Waka Kotahi NZ Transport Agency submission on a notified Far North District Proposed District Plan under Clause 6 of Schedule 1 of the Resource Management Act 1991

20 October 2022

Table 1: Decisions Sought on Proposed Far North District Plan

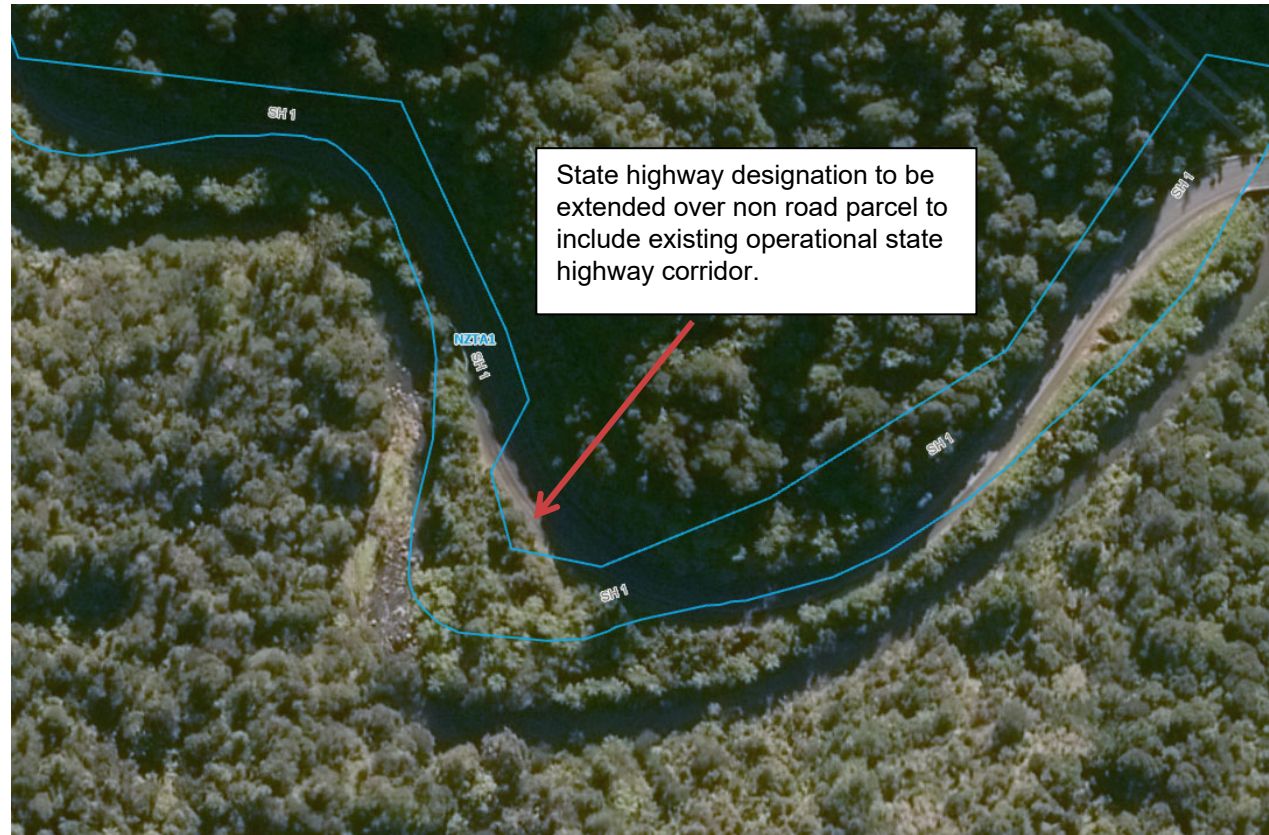
Item	Specific Provision	Support/ Support in Part/ Oppose	Comments/Reasons	Relief Sought
			<p>existing road parcel boundaries. In most cases, these discrepancies are historical in nature and modifying the designation boundary through the district plan process allows an opportunity to rectify those.</p> <p>While this land is not currently legal road, it does form part of the constructed and fully operational state highway network. The proposed modifications are designating existing state highway infrastructure that is already formed and operational and is not in private use.</p> <p>Refer Attachment A for examples of where the state highway designation boundaries will be modified.</p> <p>Waka Kotahi is currently mapping the updated designation boundaries geospatially to accurately reflect the operational state highway corridors and will provide these to Council in due course.</p>	
	Location of designation CNZ17 (Te Kao Exchange)	Support with amendments	Waka Kotahi notes that designation CNZ17 (Te Kao Exchange) appears to be in the incorrect location and also overlaps the NZTA-1 designation. From discussions with Chorus, Waka Kotahi understands the CNZ17 designation should be located further north, as shown in the image below:	<p>Waka Kotahi seeks confirmation of the correct location of the CNZ17 Te Kao Exchange designation.</p> <p style="text-align: center;">S356.126</p>

Item	Specific Provision	Support/ Support in Part/ Oppose	Comments/Reasons	Relief Sought
			 <p>Correct location of CNZ17</p> <p>Location of CNZ17 as notified</p>	
	<p>Boundaries of designations of other Requiring Authorities</p>	<p>Support in part</p>	<p>Waka Kotahi notes the inclusion of designations of other Requiring Authorities. The boundaries of some of these designations appear to overlap the state highway designation boundaries.</p> <p>Waka Kotahi seeks confirmation from these Requiring Authorities that the boundaries of their designations are correct. Refer Attachment B for examples of where other Requiring Authority designation overlaps with the state highway designations.</p>	<p>S356.127</p>

Attachment A: Examples of where the state highway designation boundary is to be modified

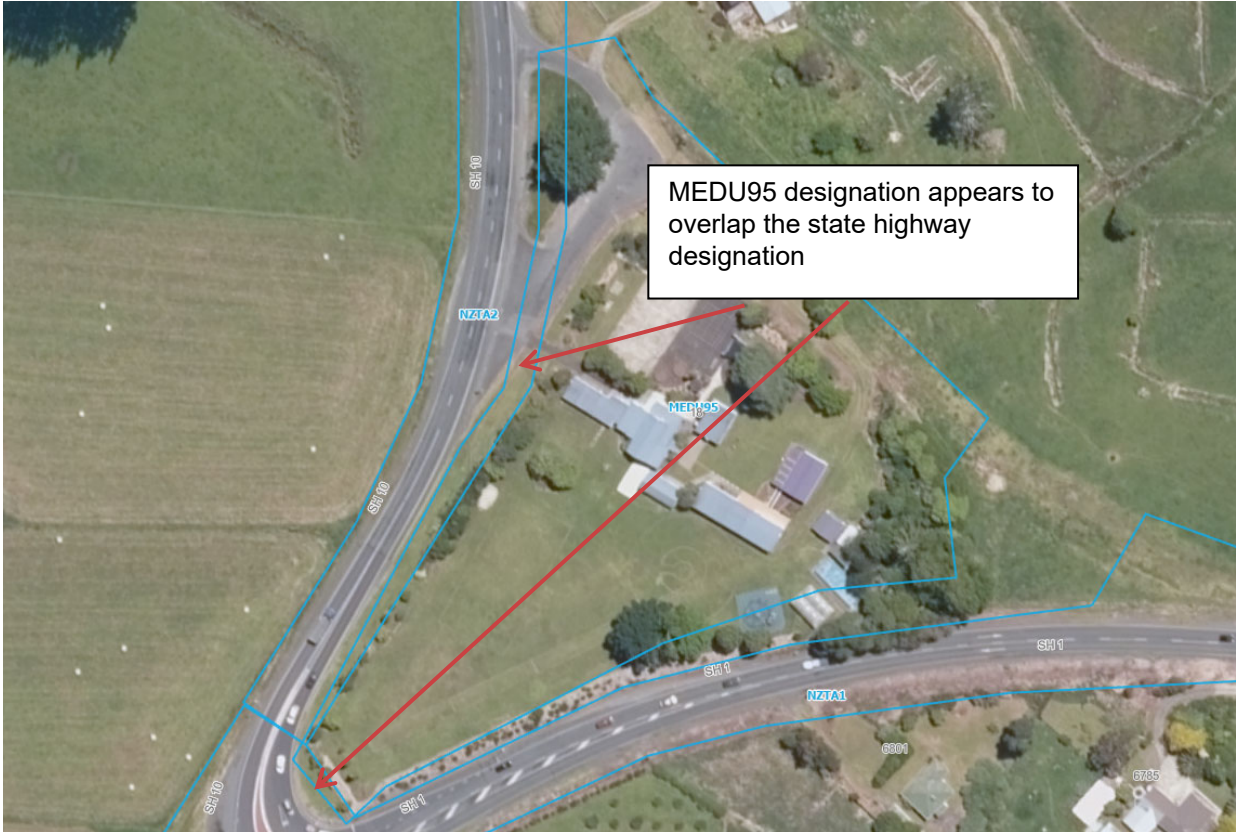
Issue	Example
<p>State highway designation to be extended over bridges / structures over waterways</p>	 <p>State highway designation to be extended over Hydro parcel to include bridge/structure</p> <p>Adjacent road parcel ID: 5221663</p>

State highway designation to be extended over non-road parcels to cover existing operational road

Parcel ID: 4899526 Section 2 Block X Maungataniwha SD
